EXHIBIT A  
MONTICELLO NUCLEAR GENERATING PLANT  
DOCKET NO. 50-263

LICENSE AMENDMENT REQUEST DATED JULY 1, 1975

PROPOSED CHANGES TO TECHNICAL SPECIFICATIONS  
APPENDIX A, OF PROVISIONAL OPERATING  
LICENSE DPR-22

FIGURE 1. OFFGAS SYSTEM MODEL

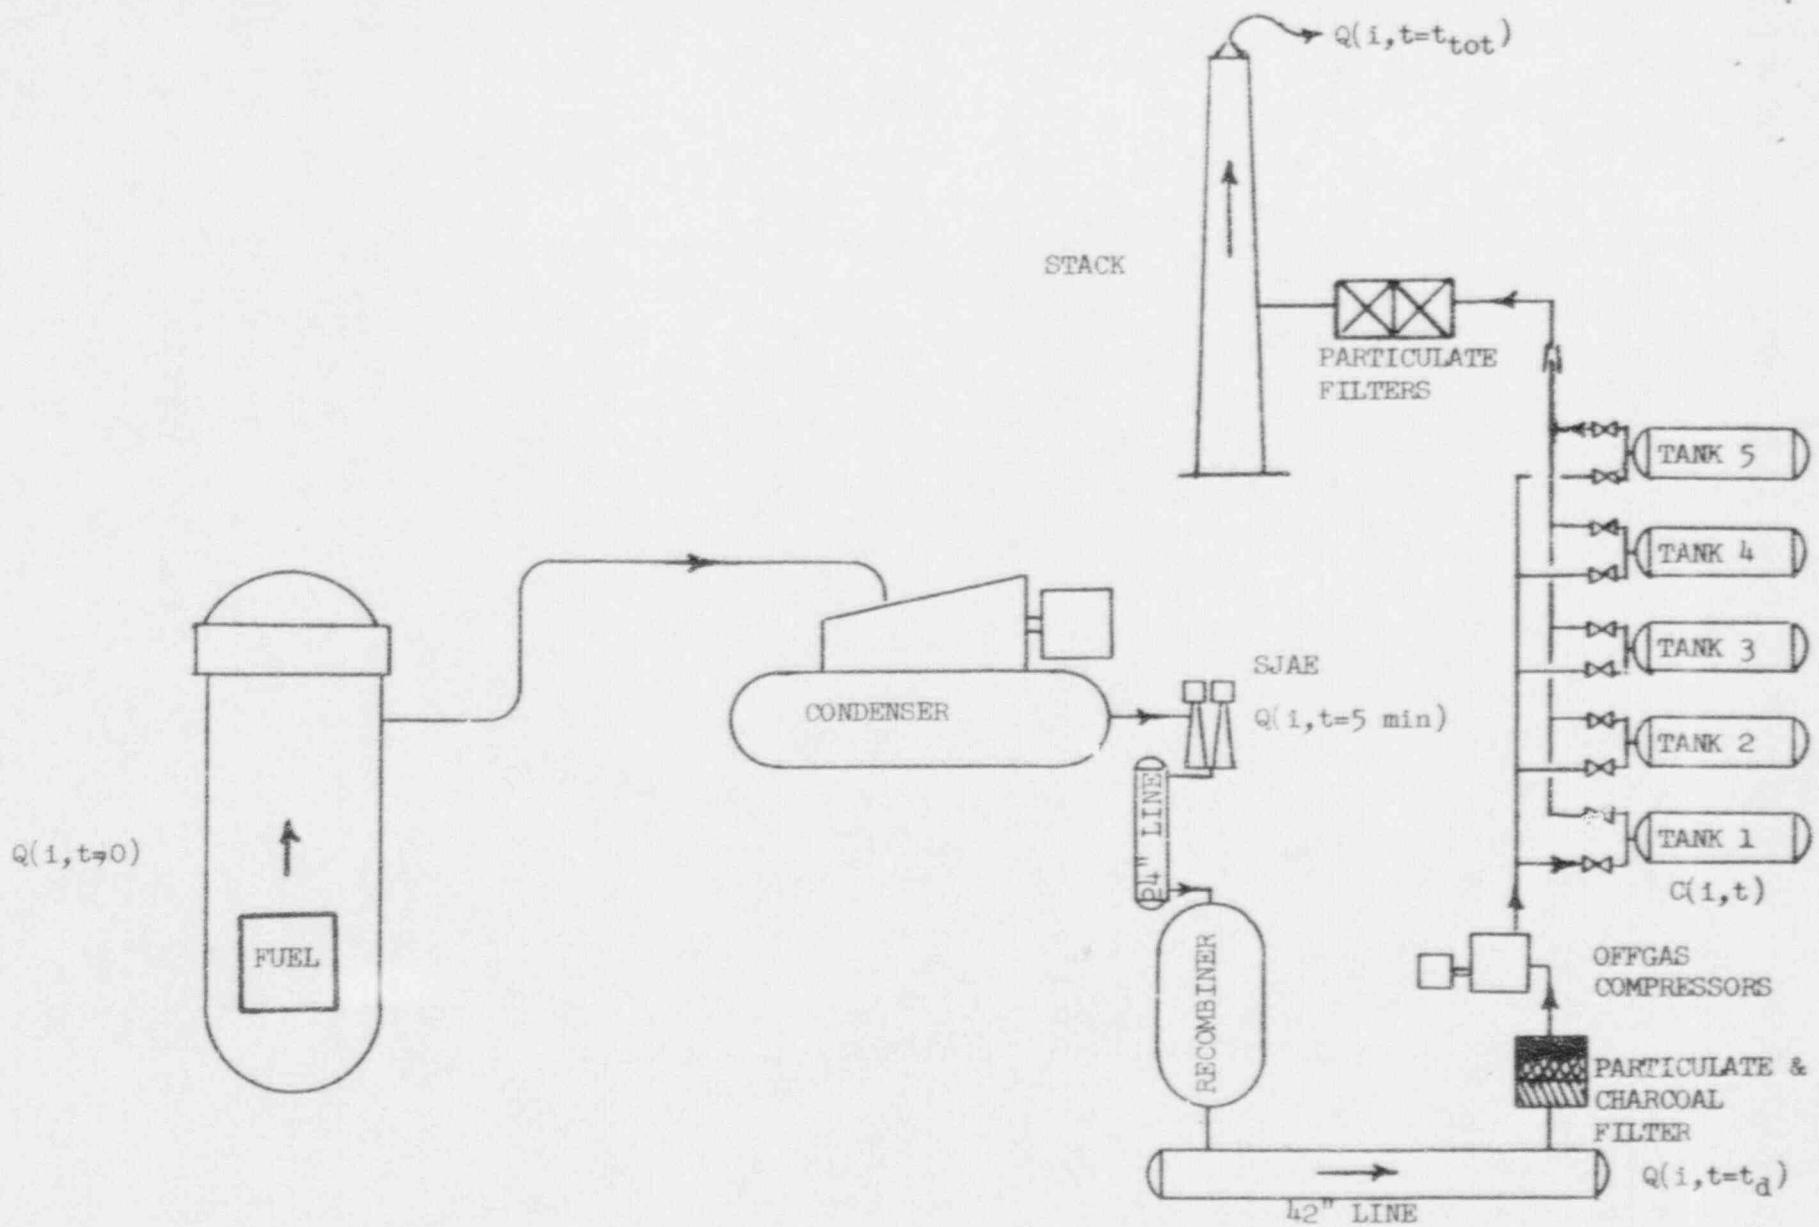
Figure 1 is a simplified flow diagram of the Monticello modified offgas system. Fission gases in the reactor vessel were assumed to be released at  $t=0$  in accordance with Table 3. Correlation between these empirical relations and actual BWR releases has been shown to be good.

FIGURE 3.6.1 Change in Charpy V Transition Temperature versus Neutron

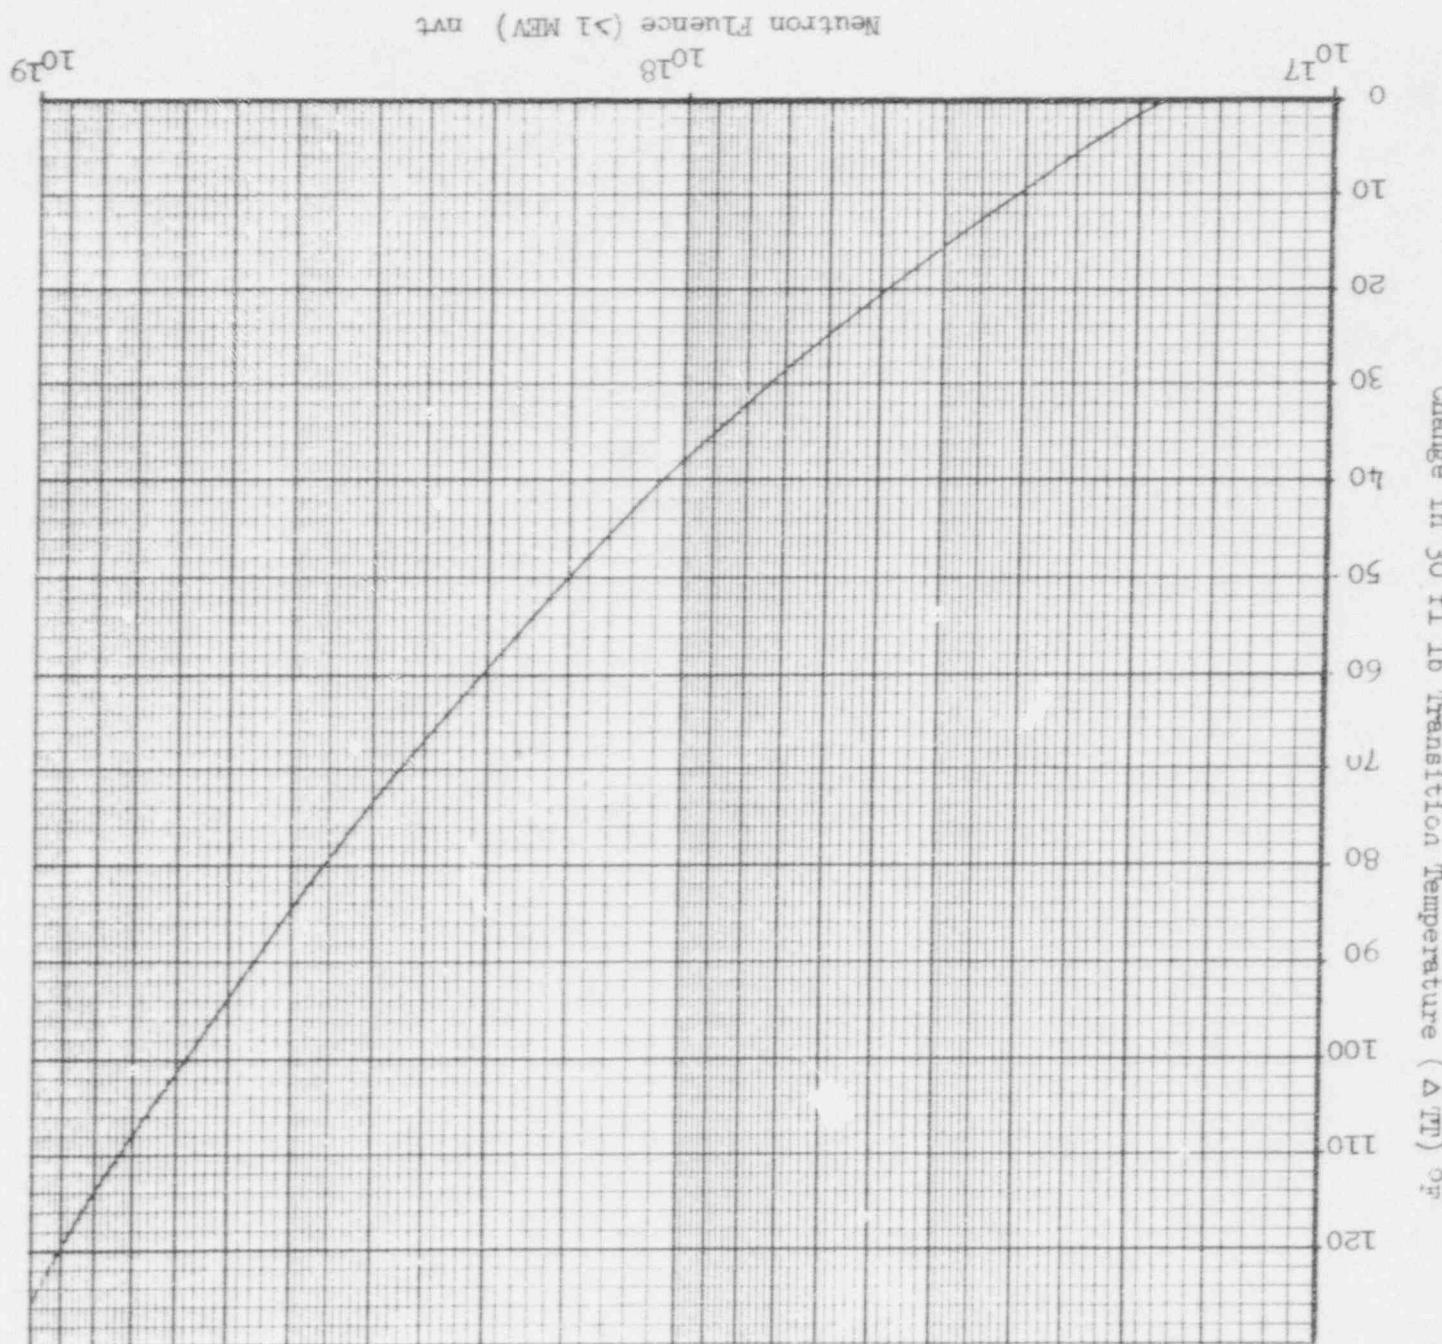
This change revises the Table of Contents and List of Figures to include the new Specification 3/4.11 and the new Figures 3.6-1 through 3.6-4 and 4.8.1.

FIGURE 3.6.2 Minimum Temperature versus Pressure for Pressure Tests

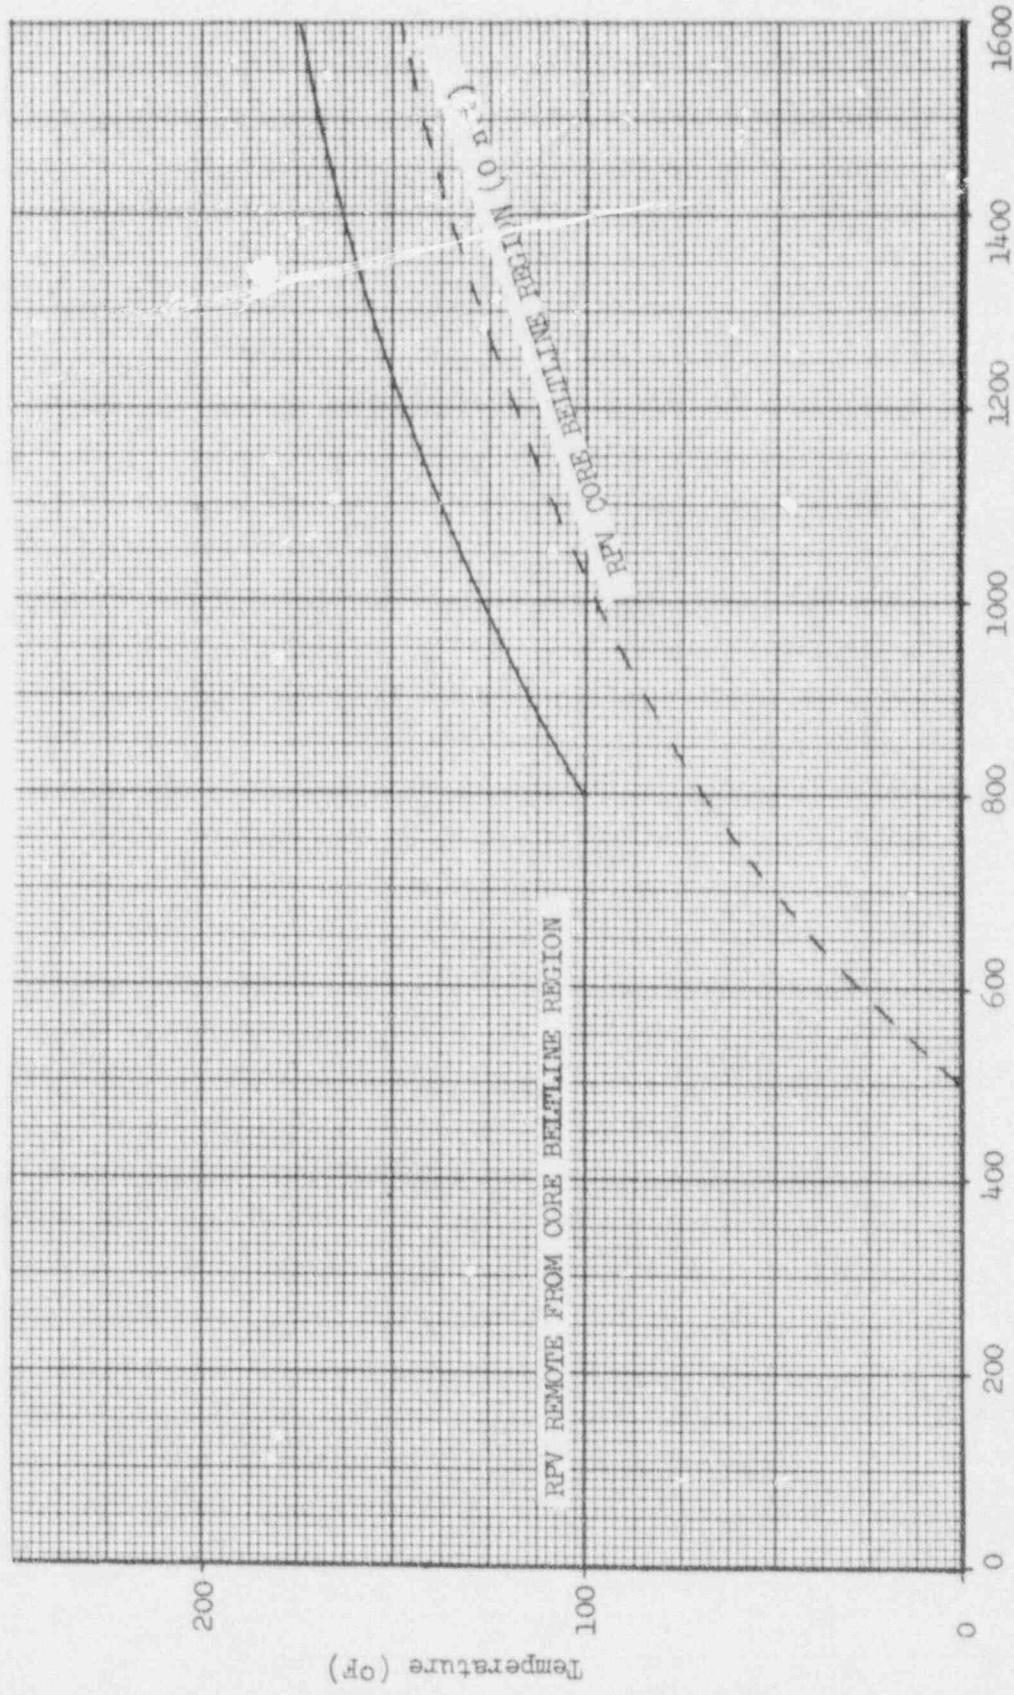
1. During in-service hydrostatic or leak testing, the reactor vessel shell temperatures specified in 4.6.B.1 shall be at or above the higher of the temperatures shown on the two curves of Figure 3.6.2 where the dashed curve, "RPV Beltline Region," is increased by the expected shift in RT<sub>NDT</sub> from Figure 3.6.1.

Figure 4.8.1. Off-Gas Storage Tank Gross Activity Limits

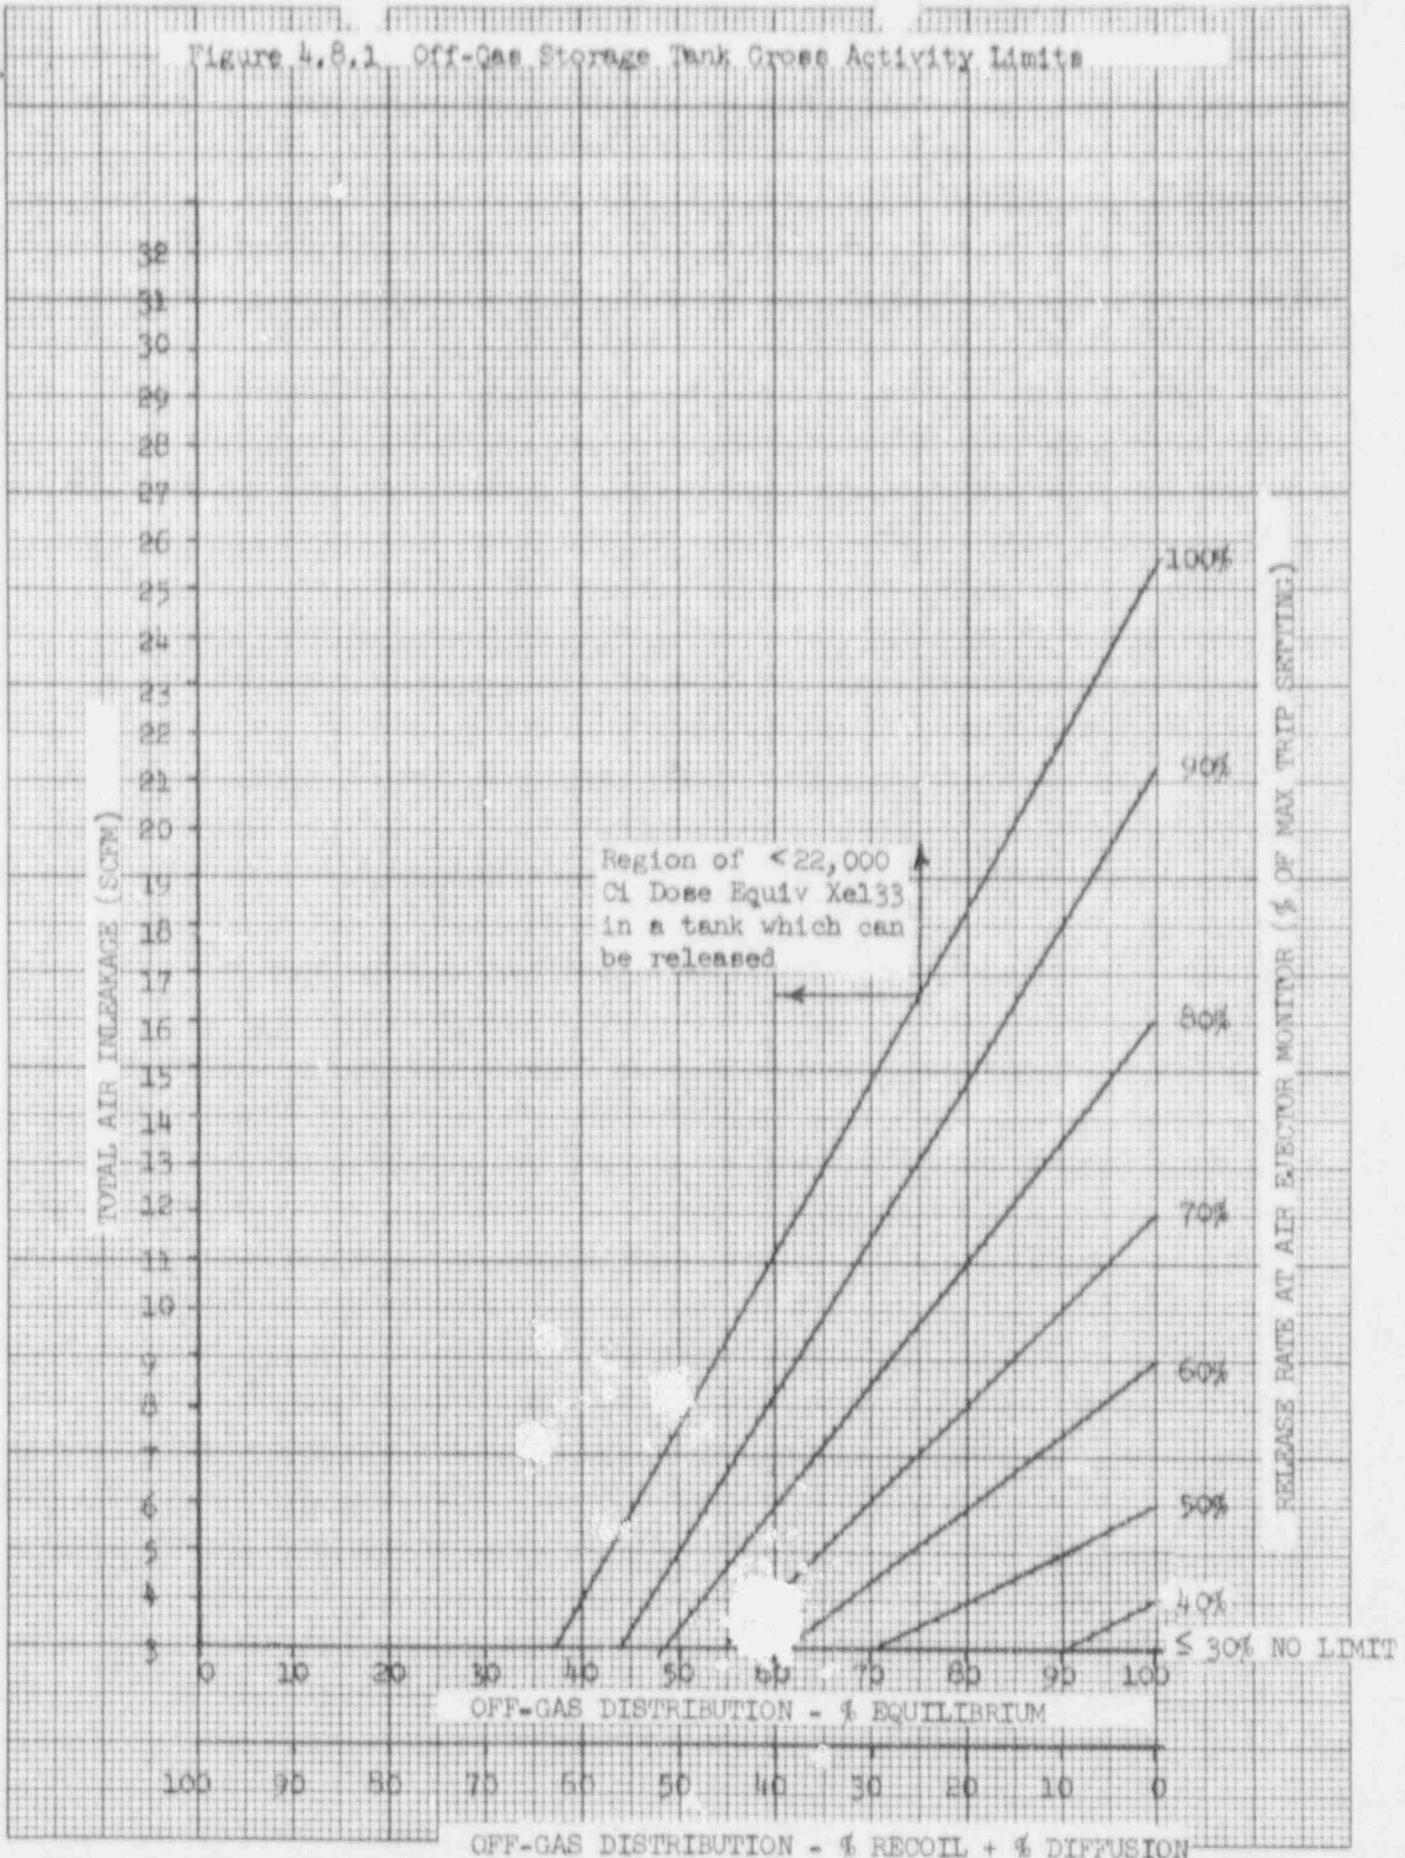
e. Add new Figure 4.8.1, "Offgas Storage Tank Gross Activity Limits," as included on page 176A of Exhibit B.

Changes (c), (d), and (e) revise the method of complying with the maximum tank contents limit of 22,000 Curies dose equivalent Xe-133. During startup testing of the augmented Off-Gas System, it was found that the compressed storage tank radiation monitors do not perform their intended function.

Calculations have been performed to determine the relationship between air ejector off-gas activity and composition and condenser air inleakage. The results of these calculations are presented in Exhibit B Figure 4.8.1. A summary of the technique used in performing these calculations is included as Appendix A to Exhibit A.

It is proposed that compliance with the 22,000 Curie dose equivalent Xe-133 tank contents limit be demonstrated by monitoring total system air inleakage and the average air ejector noble gas release rate. Using Figure 4.8.1 and the results of the most recent determination of noble gas isotopic composition at the air ejector, the contents of a storage tank can be verified to be below the activity limit.

Only under conditions of a high "equilibrium" type off-gas isotopic distribution, low condenser air inleakage, and high off-gas release rate is there the potential for exceeding the 22,000 Ci limit. As demonstrated in Appendix A to this Exhibit, Figure 4.8.1 is conservative.

2. Condenser air inleakage shall be evaluated weekly and used in conjunction with the latest steam jet air ejector off-gas isotopic analysis and Figure 4.8.1 to determine that the limit of Specification 3.8.E.4 will not be exceeded.
